Application to Modify Development Consent Notice of Determination

Development Application No: DA/2210/2022/A
Property Address: Lot 84 DP 19828,
50 Baker Street, DORA CREEK NSW 2264
Original Proposal: Alterations and Additions - Dwelling House, Attached
Garage and Carport
Modification sought: Change from Garage to Carport
Determination Status: Amended Approval
Determination Date: 5 January 2023
Consent to operate from: 25 October 2022
Consent to lapse on: 25 October 2027

Project
Proposed Addition,
Garage & Carport

THIS SHEET - 2

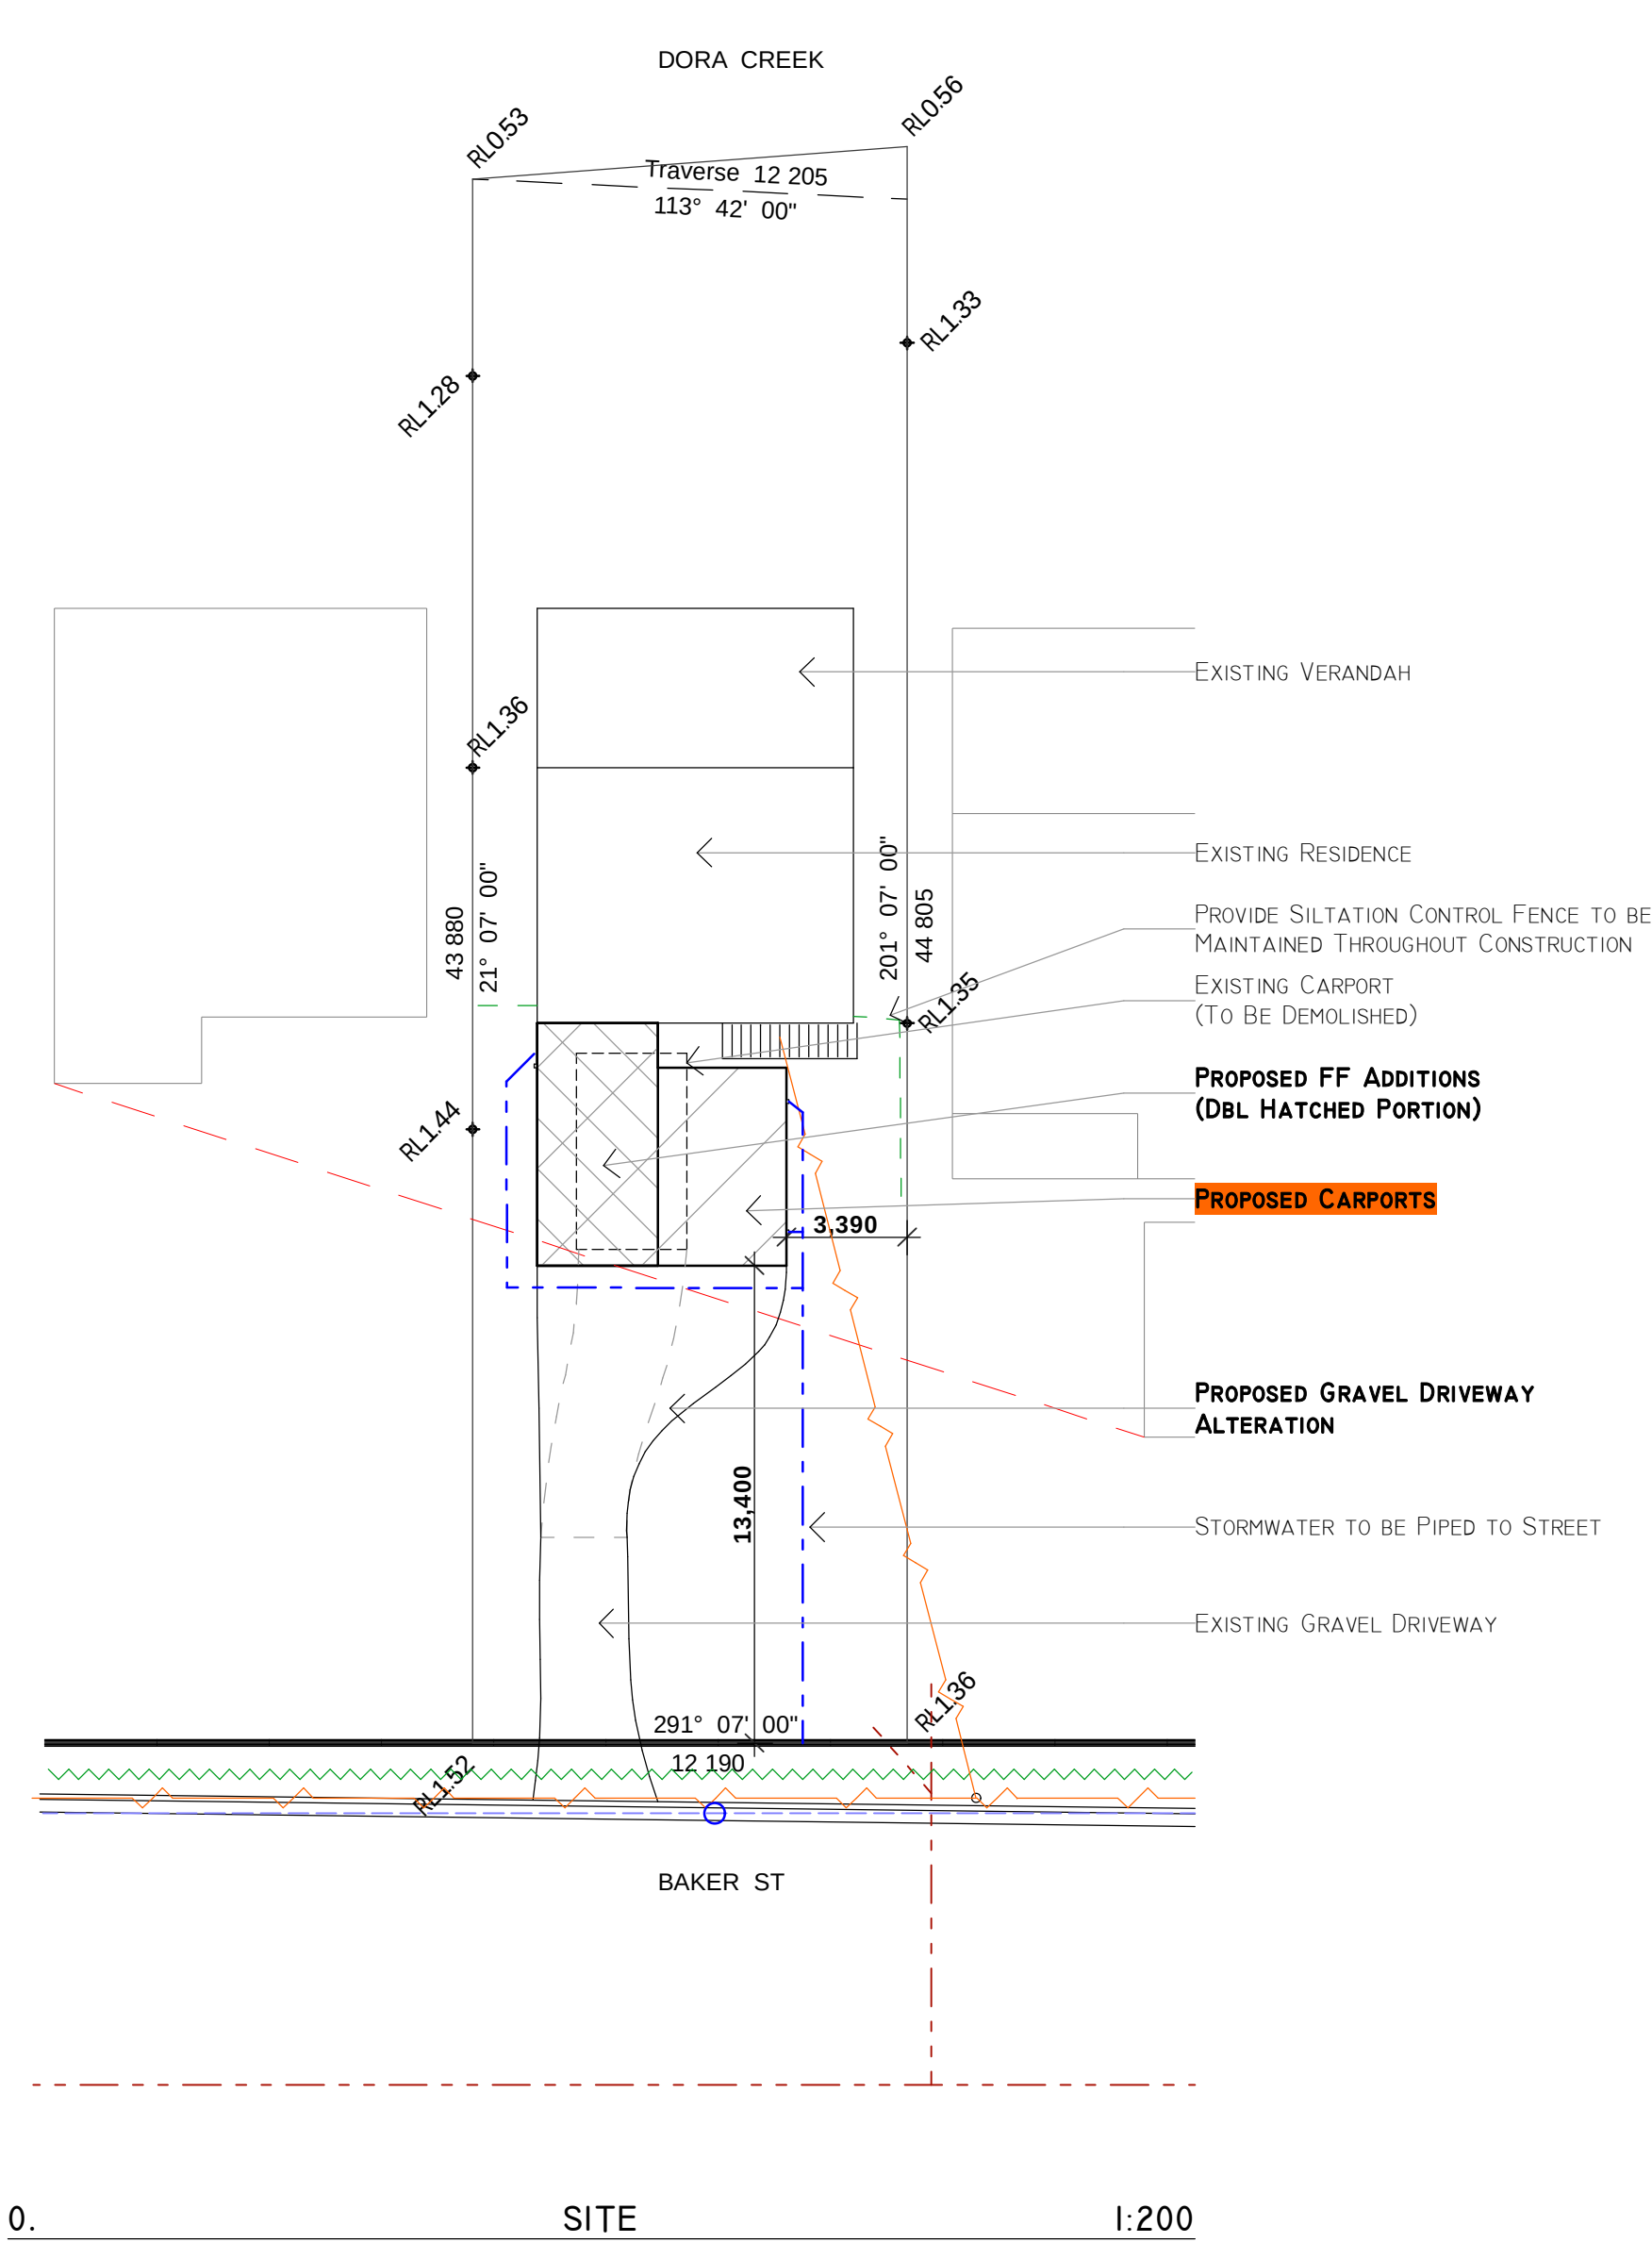
25/11/22 - SECTION 4.55
APPLICATION TO DELETE ENCLOSING WALLS TO ALTER GARAGE TO BECOME OPEN CARPORT & TO ALTERED THE APPROVED GARAGE FLOOR LEVEL.

20/12/22 - DELETE GARAGE ROLLER DOOR.
